RE Addendum to OU6 EE Sampling and Analysis Plan

SUBJECT REVIEW OF DRAFT OF ADDENDUM NO 1 ADDITIONAL POND SEDIMENT  
INVESTIGATIONS - FAV-113-94

RE Comments on Draft RFI/RI EE SAP/FSP Addendum No 1

# REVIEW COMMENT SHEET

# PCB CONCENTRATION IN SEDIMENTS

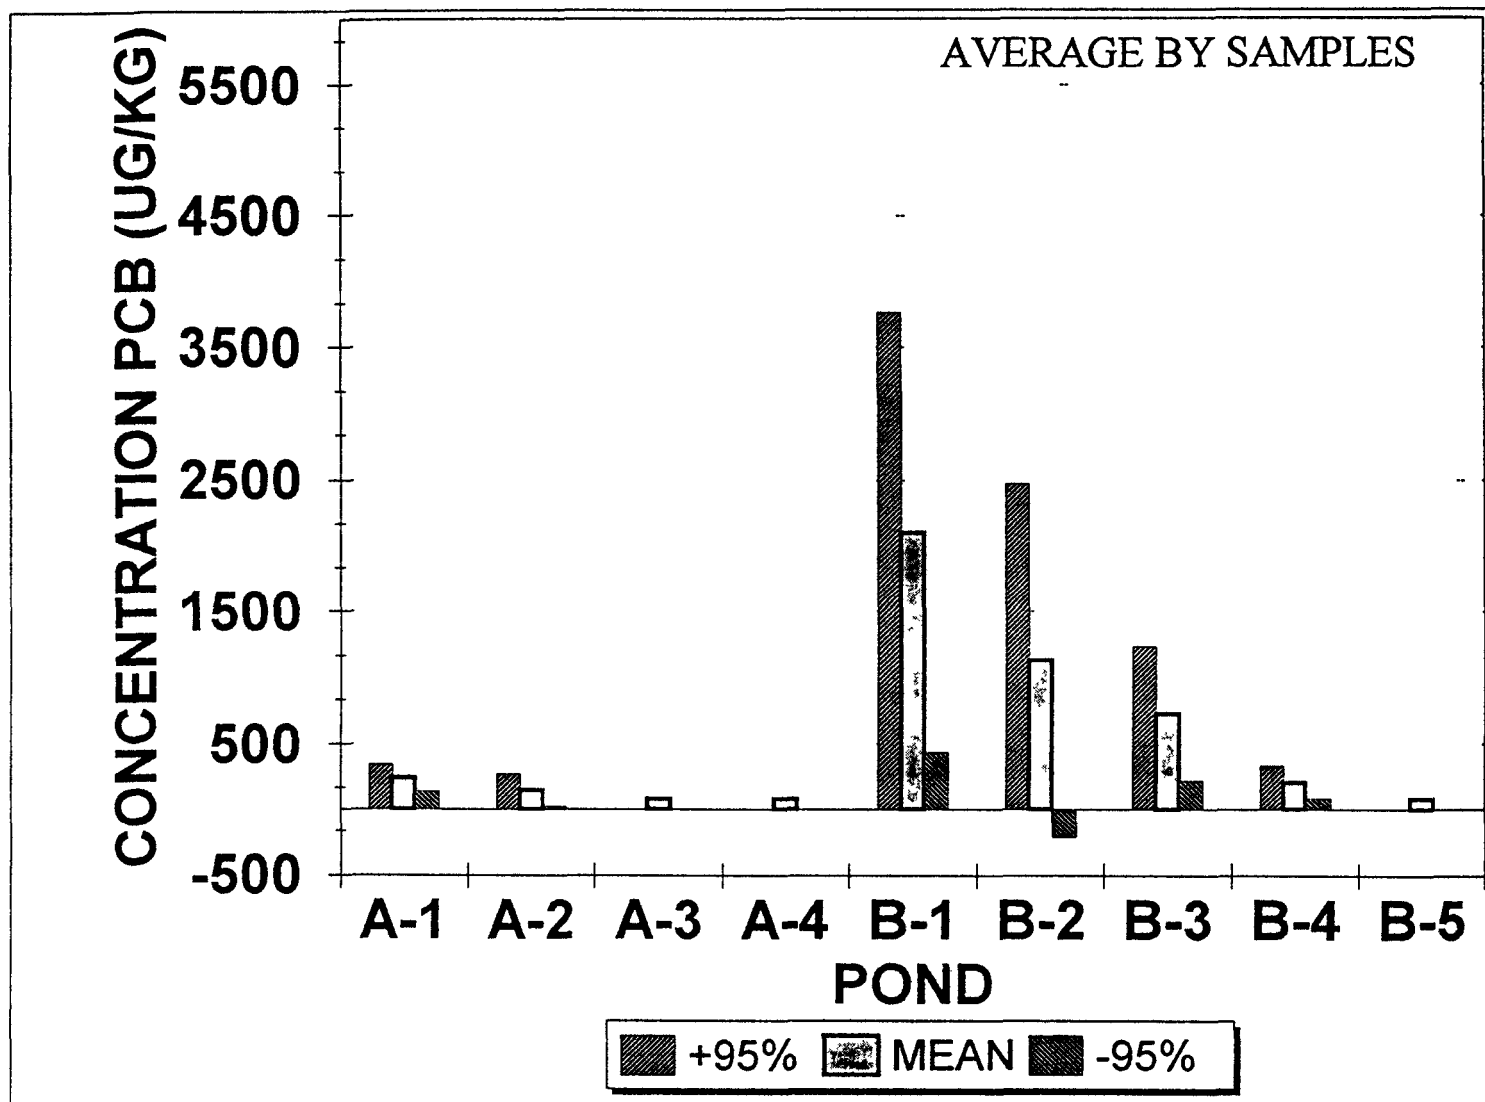
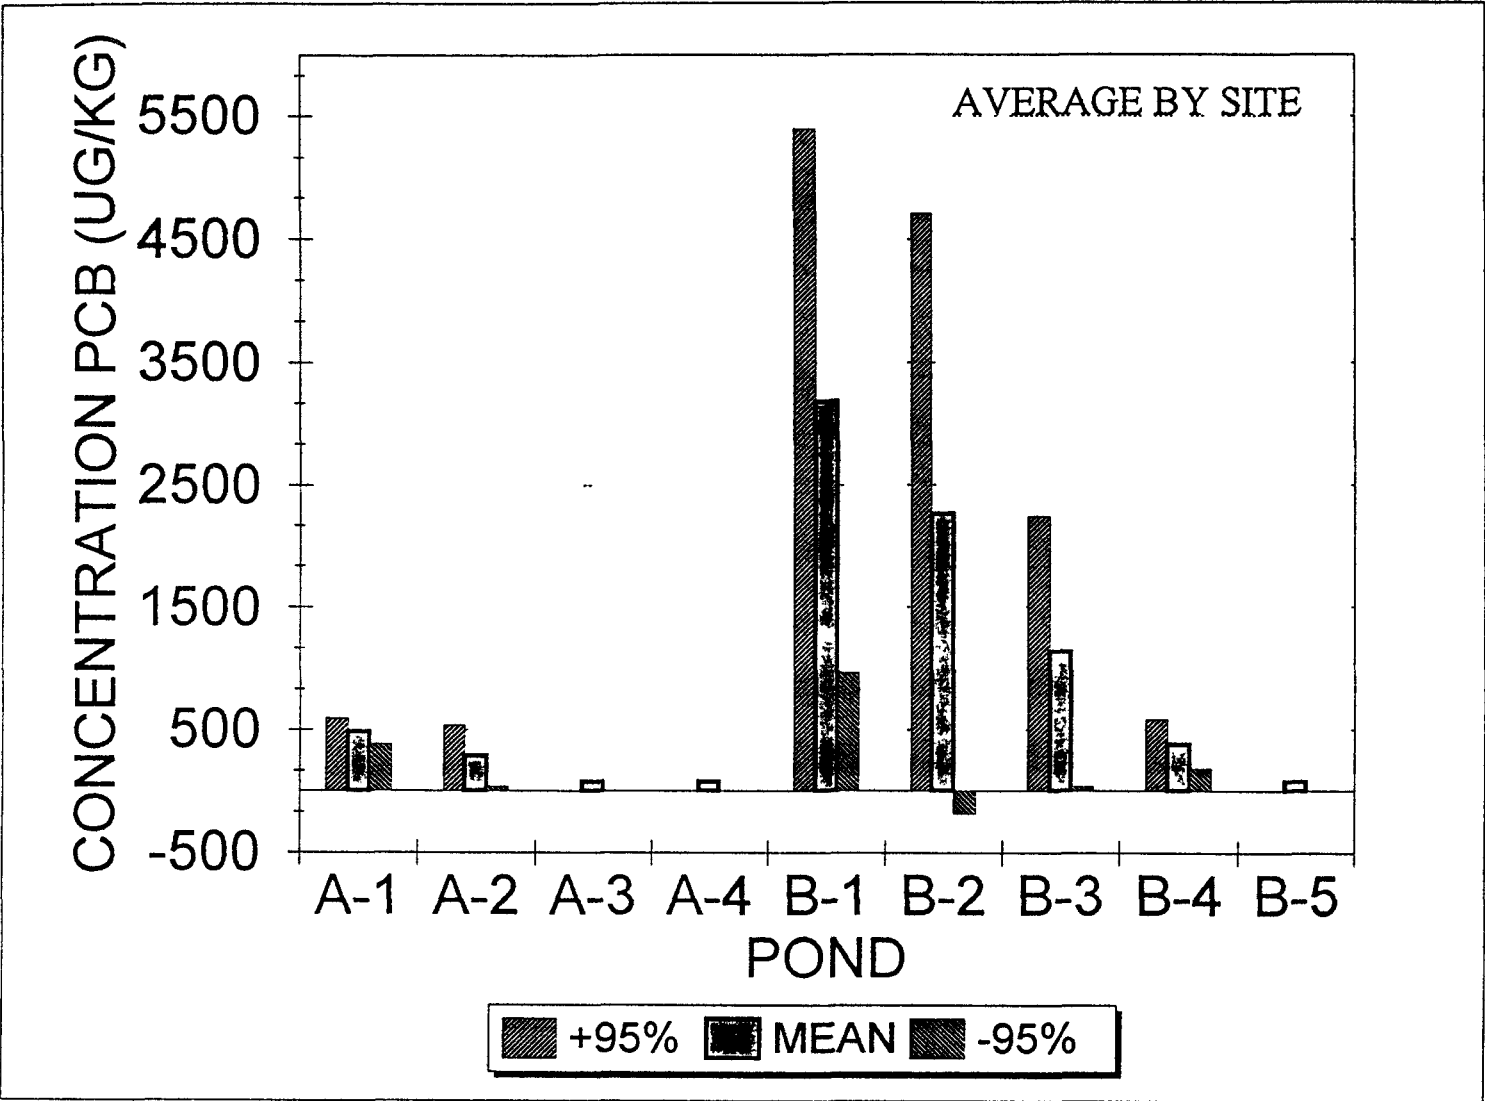
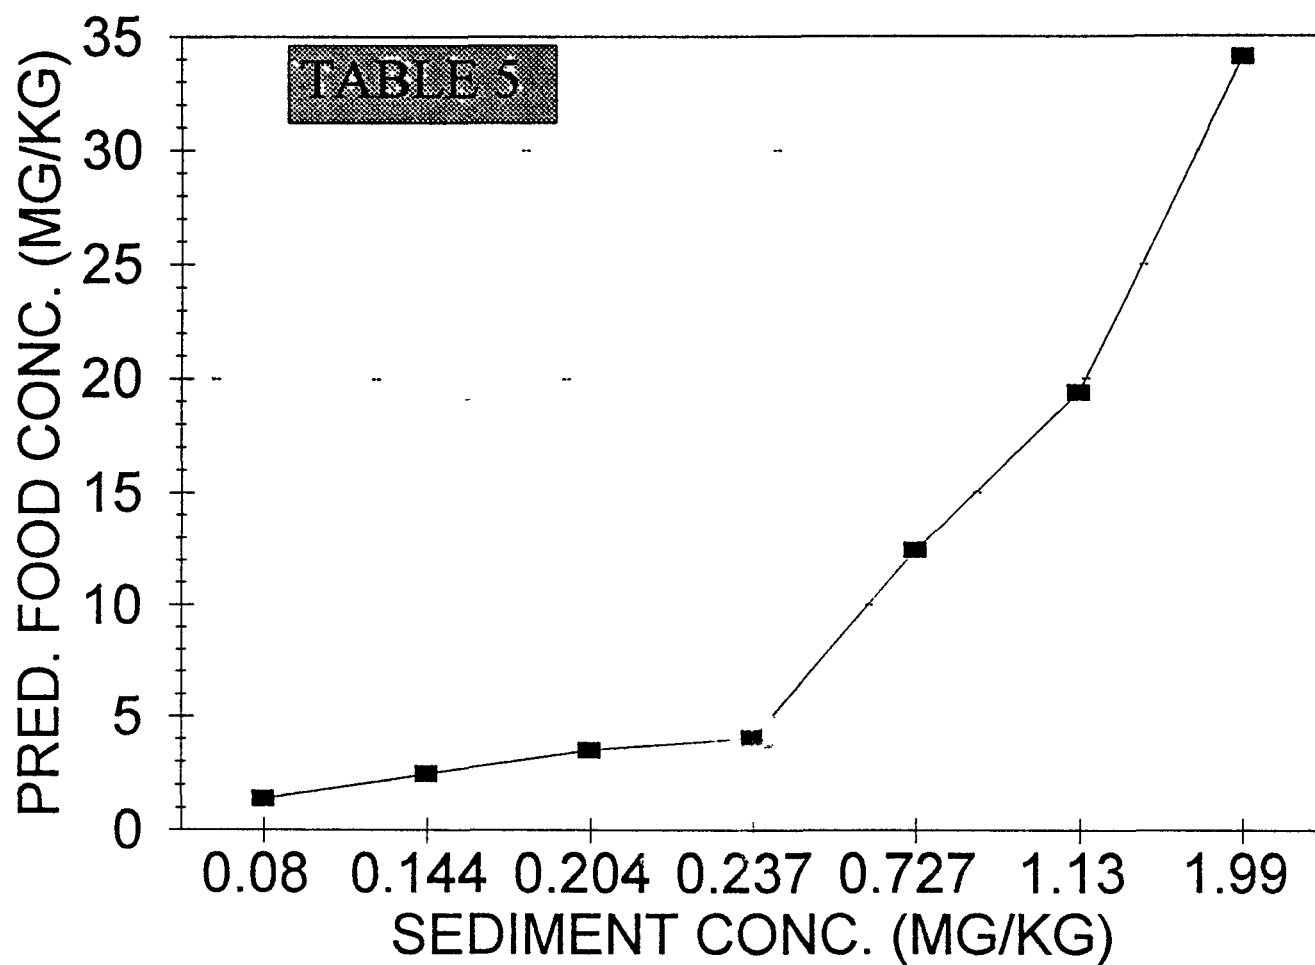
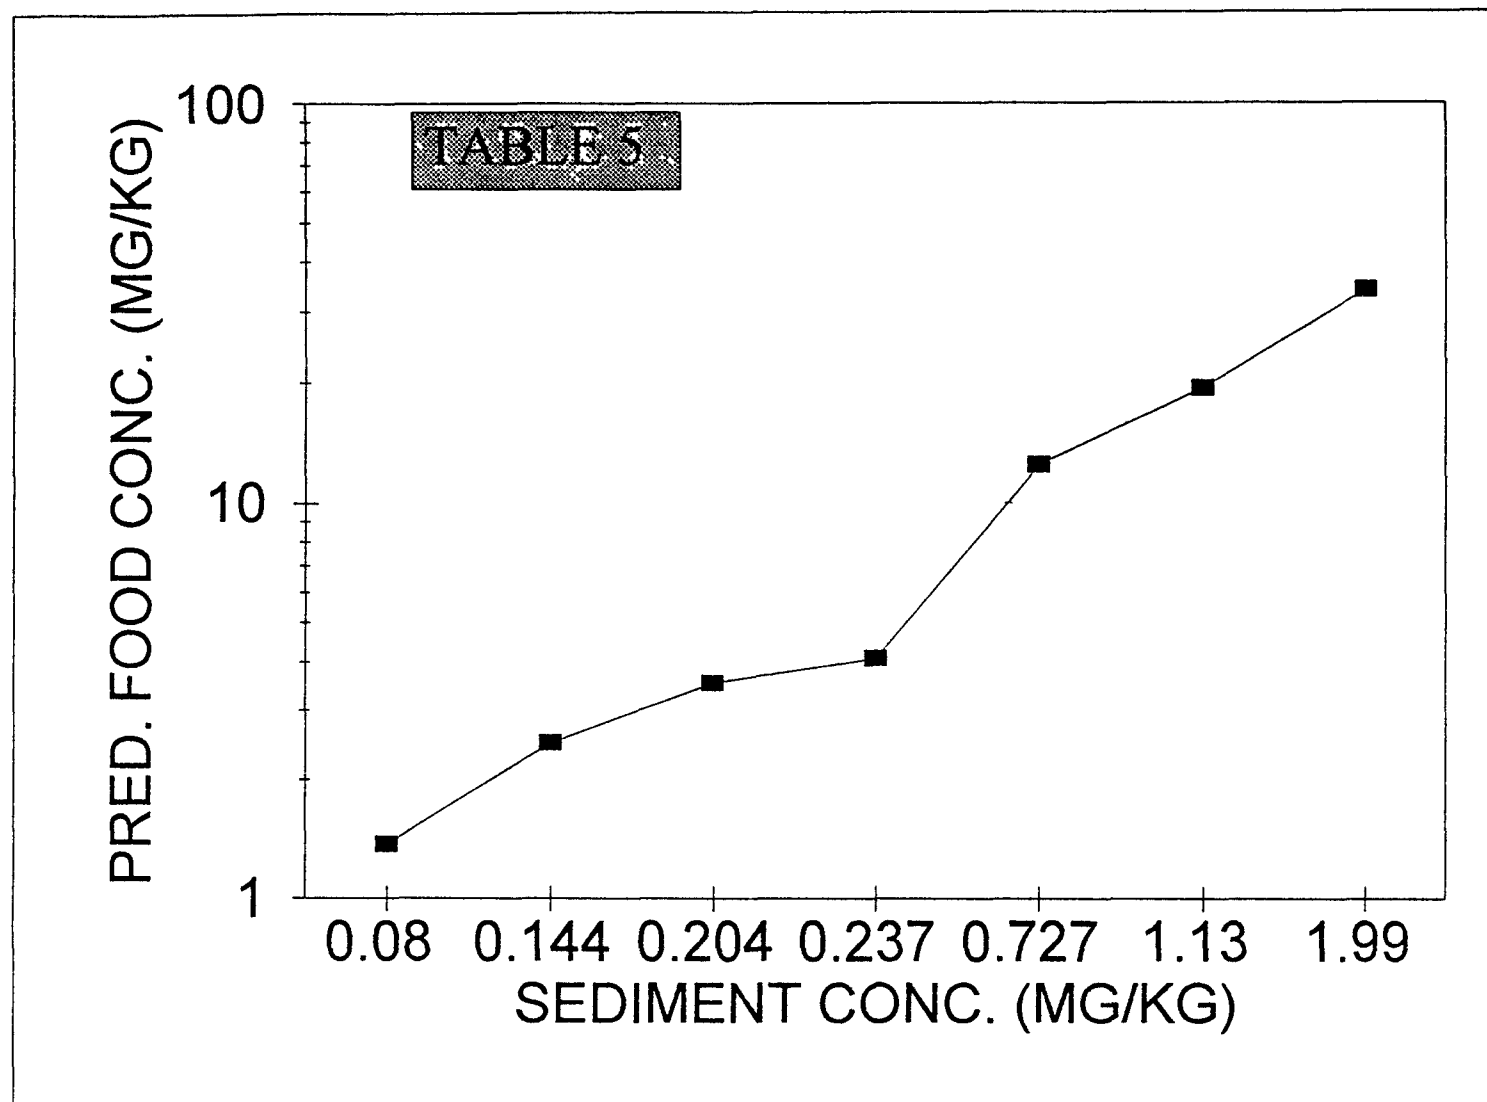
A major flaw in the summarization of the sediment chemistry must be remedied Data are averaged for all samples when sample data should be summarized by sample site first, then sample site data can be averaged to provide estimates of average pond concentrations I have done a comparison of the two approaches to summarizing these data Data are presented in the attached Tables and Figures and show significant differences which bare on the findings of this report

- Fig 3 Should be redrawn with proper means and confidence intervals I have provided an example Given the sample variability the trend in concentrations from upstream to downstream is not as clear cut We know nothing about the variability in the below detection limit ponds. Considering that ponds with significant PCB levels also, at some sample locations, find no detectable PCB one wonders if the systems were sampled well enough to conclude there is no PCB in the terminal A and B series ponds I strongly believe that more intensive sampling of sediment PCBs is required
